Jeffery D. Harris  
jdh@eslawfirm.com

February 28, 2019

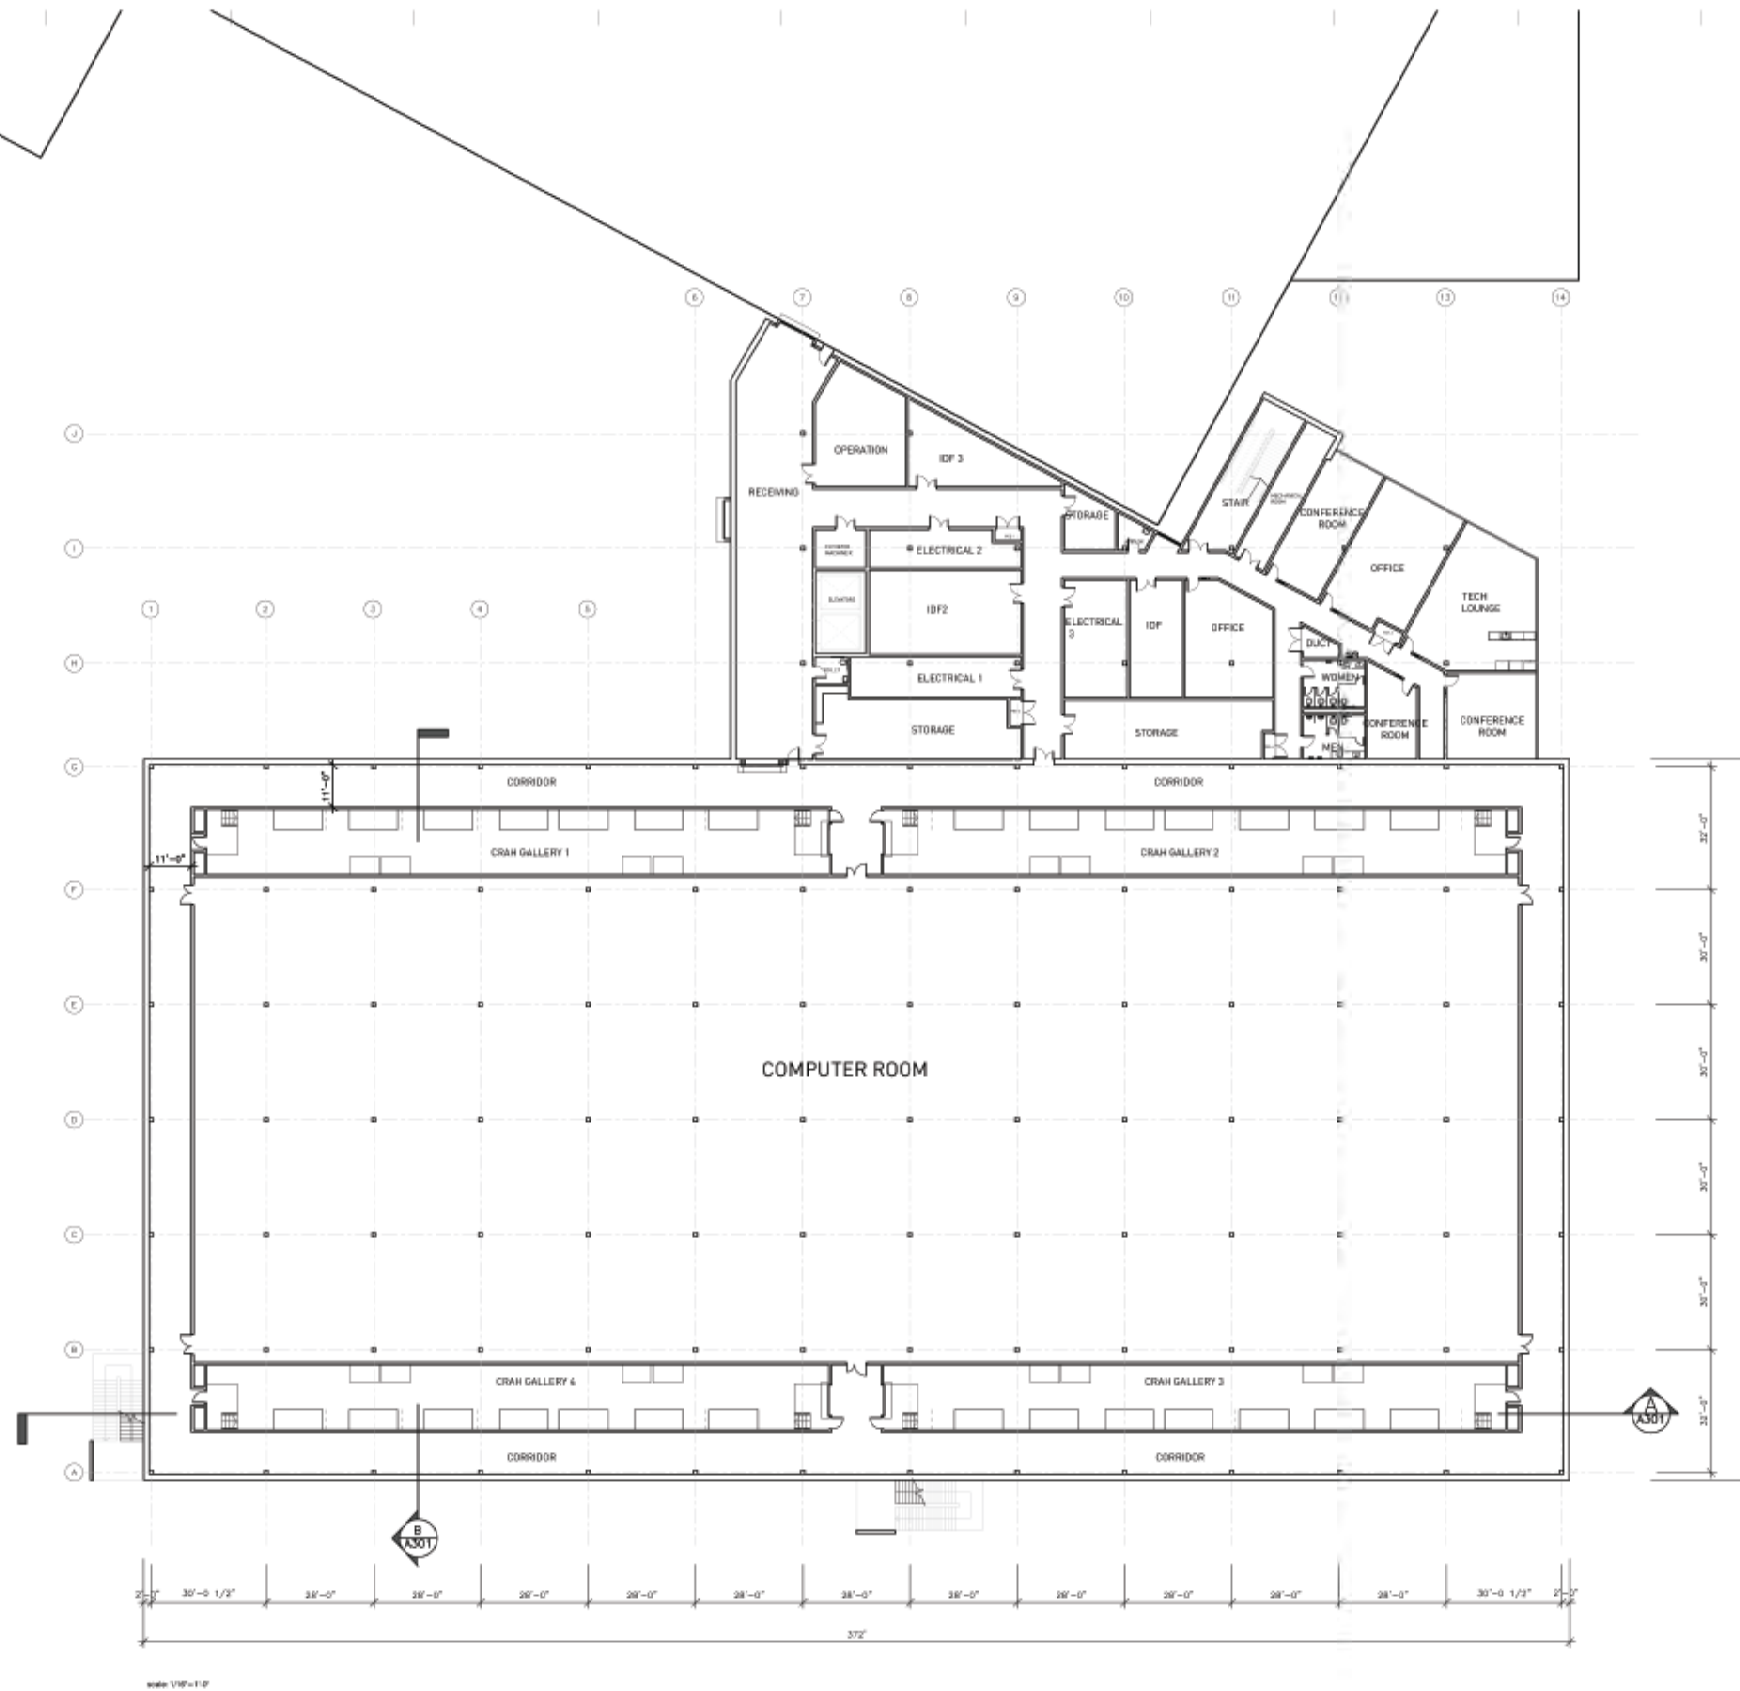
NO.	REVISION	DATE
1	ISSUED FOR PERMIT	01/15/2014
2	REVISED PER COMMENTS	02/10/2014
3	REVISED PER COMMENTS	02/10/2014
4	REVISED PER COMMENTS	02/10/2014
5	REVISED PER COMMENTS	02/10/2014
6	REVISED PER COMMENTS	02/10/2014
7	REVISED PER COMMENTS	02/10/2014
8	REVISED PER COMMENTS	02/10/2014
9	REVISED PER COMMENTS	02/10/2014
10	REVISED PER COMMENTS	02/10/2014
11	REVISED PER COMMENTS	02/10/2014
12	REVISED PER COMMENTS	02/10/2014
13	REVISED PER COMMENTS	02/10/2014
14	REVISED PER COMMENTS	02/10/2014
15	REVISED PER COMMENTS	02/10/2014
16	REVISED PER COMMENTS	02/10/2014
17	REVISED PER COMMENTS	02/10/2014
18	REVISED PER COMMENTS	02/10/2014
19	REVISED PER COMMENTS	02/10/2014
20	REVISED PER COMMENTS	02/10/2014
21	REVISED PER COMMENTS	02/10/2014
22	REVISED PER COMMENTS	02/10/2014
23	REVISED PER COMMENTS	02/10/2014
24	REVISED PER COMMENTS	02/10/2014
25	REVISED PER COMMENTS	02/10/2014
26	REVISED PER COMMENTS	02/10/2014
27	REVISED PER COMMENTS	02/10/2014

28	REVISED PER COMMENTS	02/10/2014
29	REVISED PER COMMENTS	02/10/2014
30	REVISED PER COMMENTS	02/10/2014
31	REVISED PER COMMENTS	02/10/2014
32	REVISED PER COMMENTS	02/10/2014
33	REVISED PER COMMENTS	02/10/2014
34	REVISED PER COMMENTS	02/10/2014
35	REVISED PER COMMENTS	02/10/2014
36	REVISED PER COMMENTS	02/10/2014
37	REVISED PER COMMENTS	02/10/2014
38	REVISED PER COMMENTS	02/10/2014
39	REVISED PER COMMENTS	02/10/2014
40	REVISED PER COMMENTS	02/10/2014
41	REVISED PER COMMENTS	02/10/2014
42	REVISED PER COMMENTS	02/10/2014
43	REVISED PER COMMENTS	02/10/2014
44	REVISED PER COMMENTS	02/10/2014
45	REVISED PER COMMENTS	02/10/2014
46	REVISED PER COMMENTS	02/10/2014
47	REVISED PER COMMENTS	02/10/2014
48	REVISED PER COMMENTS	02/10/2014
49	REVISED PER COMMENTS	02/10/2014
50	REVISED PER COMMENTS	02/10/2014
51	REVISED PER COMMENTS	02/10/2014
52	REVISED PER COMMENTS	02/10/2014
53	REVISED PER COMMENTS	02/10/2014
54	REVISED PER COMMENTS	02/10/2014

55	REVISED PER COMMENTS	02/10/2014
56	REVISED PER COMMENTS	02/10/2014
57	REVISED PER COMMENTS	02/10/2014
58	REVISED PER COMMENTS	02/10/2014
59	REVISED PER COMMENTS	02/10/2014
60	REVISED PER COMMENTS	02/10/2014
61	REVISED PER COMMENTS	02/10/2014
62	REVISED PER COMMENTS	02/10/2014
63	REVISED PER COMMENTS	02/10/2014
64	REVISED PER COMMENTS	02/10/2014
65	REVISED PER COMMENTS	02/10/2014
66	REVISED PER COMMENTS	02/10/2014
67	REVISED PER COMMENTS	02/10/2014
68	REVISED PER COMMENTS	02/10/2014
69	REVISED PER COMMENTS	02/10/2014
70	REVISED PER COMMENTS	02/10/2014
71	REVISED PER COMMENTS	02/10/2014
72	REVISED PER COMMENTS	02/10/2014
73	REVISED PER COMMENTS	02/10/2014
74	REVISED PER COMMENTS	02/10/2014
75	REVISED PER COMMENTS	02/10/2014
76	REVISED PER COMMENTS	02/10/2014
77	REVISED PER COMMENTS	02/10/2014
78	REVISED PER COMMENTS	02/10/2014
79	REVISED PER COMMENTS	02/10/2014
80	REVISED PER COMMENTS	02/10/2014
81	REVISED PER COMMENTS	02/10/2014
